FCPF:ALS
40-8027
SUB-1010, Amendment No. 9

DOCKET NO.: 40-8027
APPLICANT: Kerr-McGee Nuclear Corporation
FACILITY: Sequoyah Uranium Hexafluoride Production Plant
SUBJECT: SAFET EVALUATION REPORT - LICENSE AMENDMENT APPLICATION
FOR AUTHORIZATION TO CONSTRUCT AND USE OF A NEW LIQUID
WASTE STORAGE POND NO. 3, LICENSE NO. SUB-1010,
AMENDMENT NO. 10

~~Figure~~ Figure Pipeline system to detect deep 510

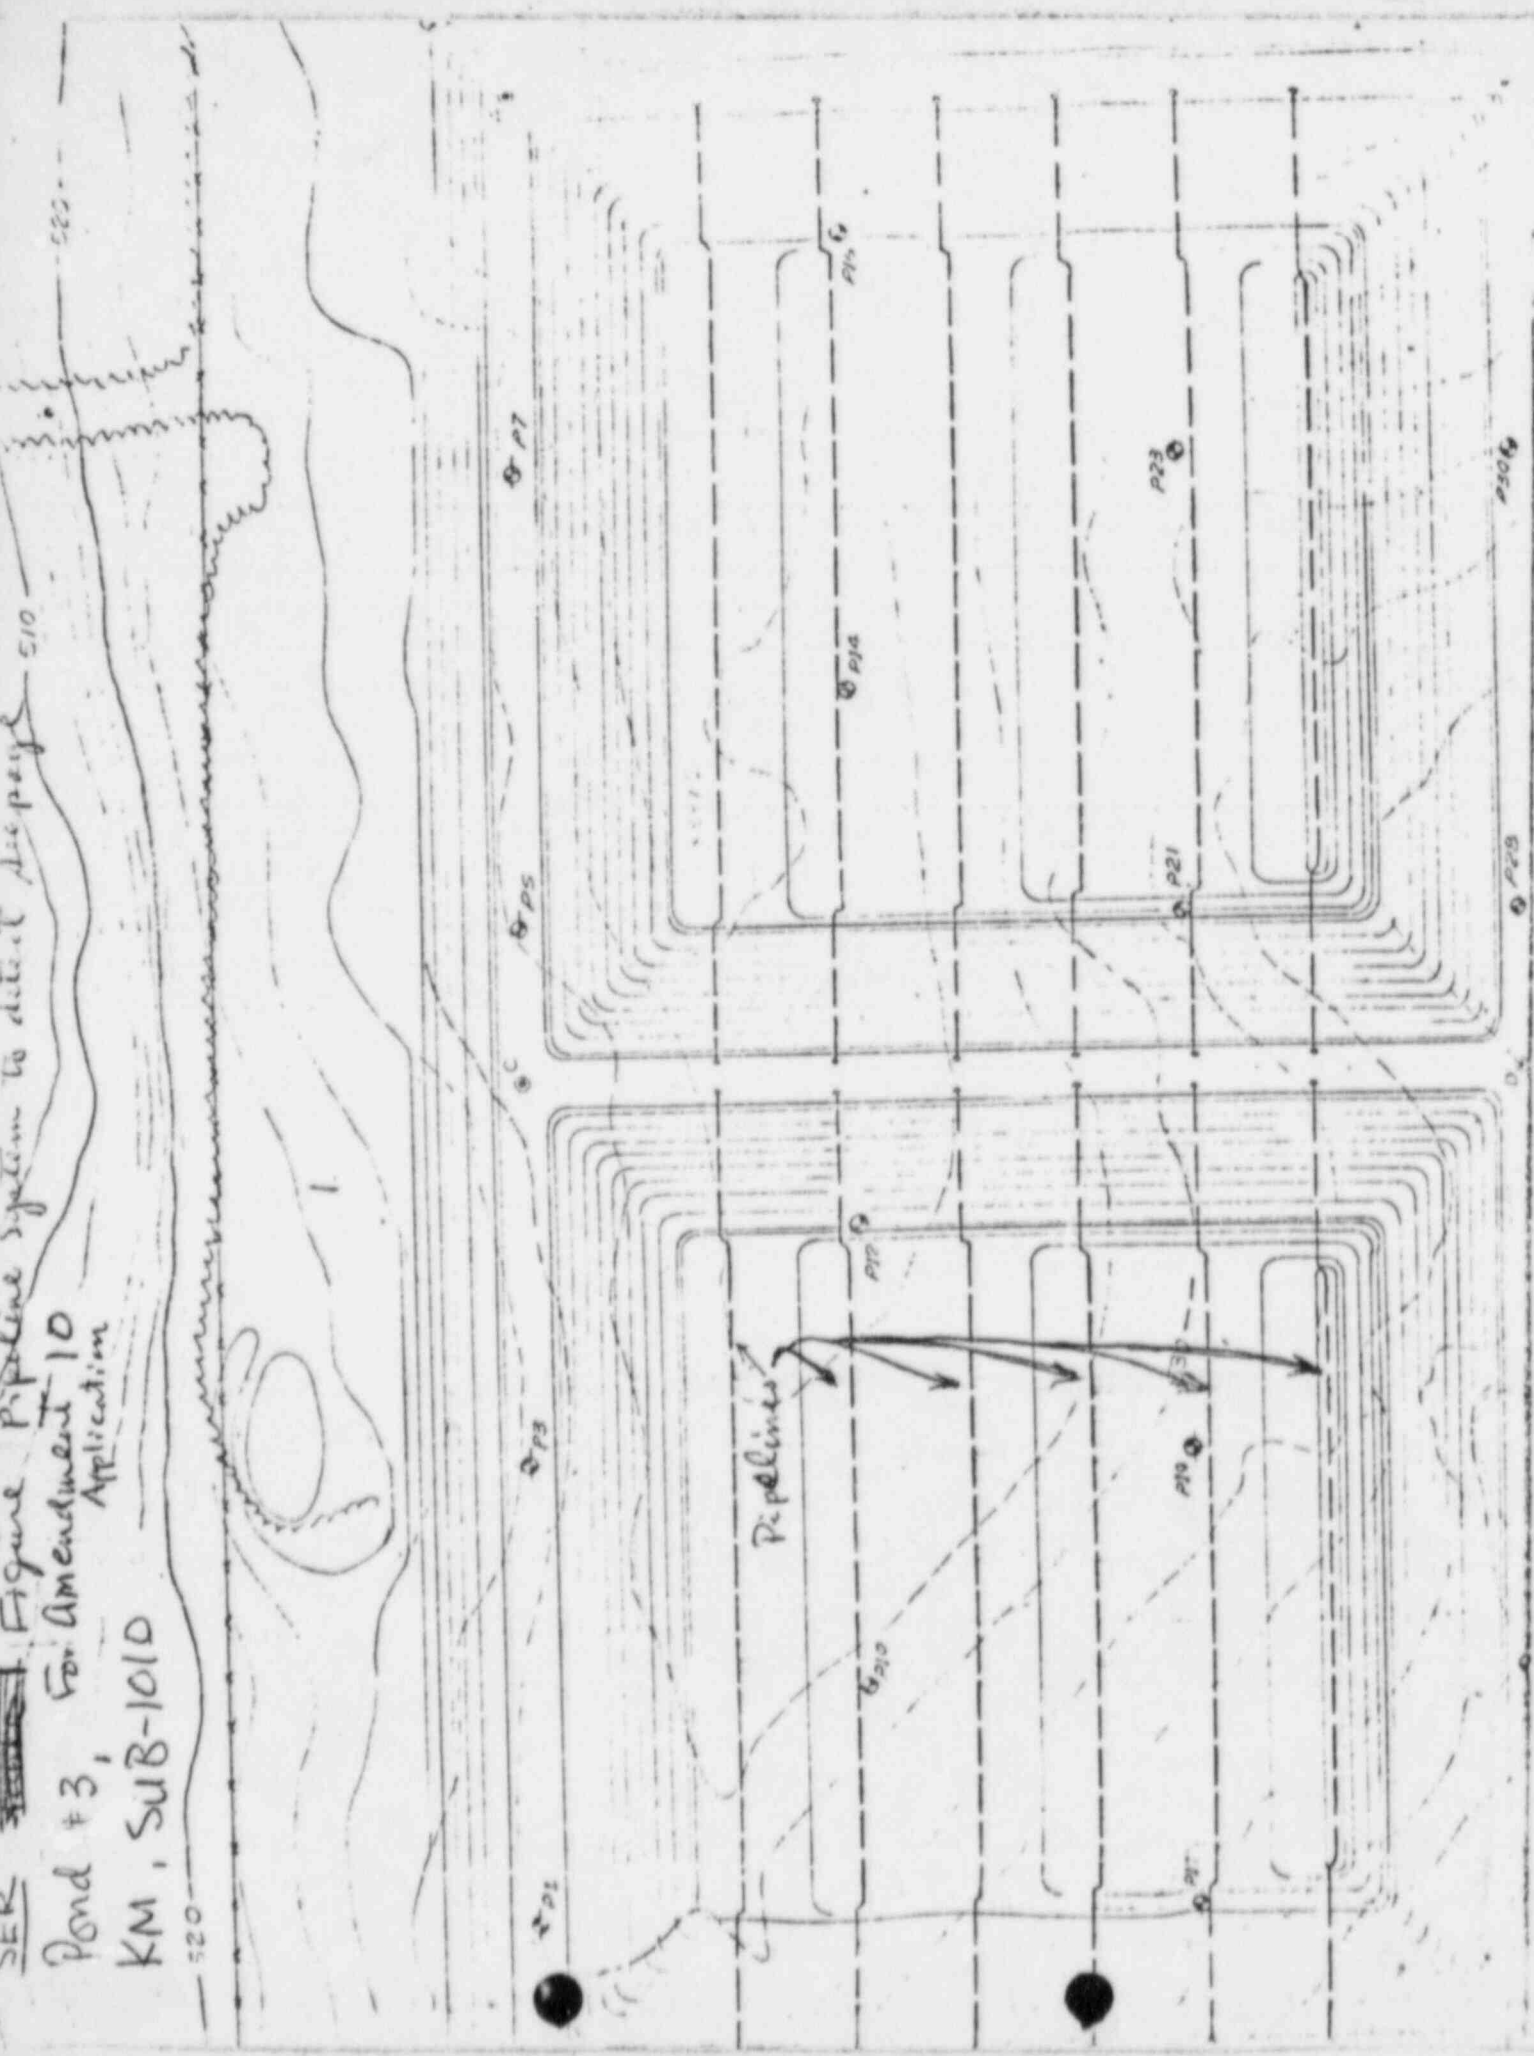
- (1) Perforated pipelines system: six perforated pipelines extending East to West across each basin beneath the liners, providing twelve sampling points for each basin (see attached figure).
- (2) Monitoring wells system: Underground water of the site will be monitored by four wells; one at each corner outside of the pond, ranging from 32 feet deep to 42 feet deep (water table of the site was estimated to be less than 32 feet).

Monitoring program for detecting the leakage from the pond will be conducted routinely by twelve sampling points from the perforated pipeline collection system and four sampling points from four wells.

Each sampling point of the pipeline system representing about 8.3% of the basin area and it is unlikely that the monitor wells would collect pond liquid without the pipeline system detecting any seepage. The liquid samples collected from pipeline system will be analyzed for nitrate and condition will be added to require that the sample be analyzed for both gross alpha and nitrate to detect seepage. The liquid sample taken from four wells monthly will be analyzed for gross alpha, beta, nitrate, floride, uranium and radium. The action levels and corrective action to be taken proposed in the application have been reviewed by the staff and considered acceptable.

1. Use of new constructed pond no. 3 shall comply with Condition No. 13 of Source Material License No. SUB-1010 dated October 7, 1977.
2. Detail plans for remodeling of pond no. 1 shall be submitted to USNRC for review prior to implementation.
3. Routine liquid samples collected from the pipeline system shall be analyzed for both gross alpha and nitrate to detect leakage.
4. The new pond to be constructed shall be used only for storage of the treated raffinate solution.
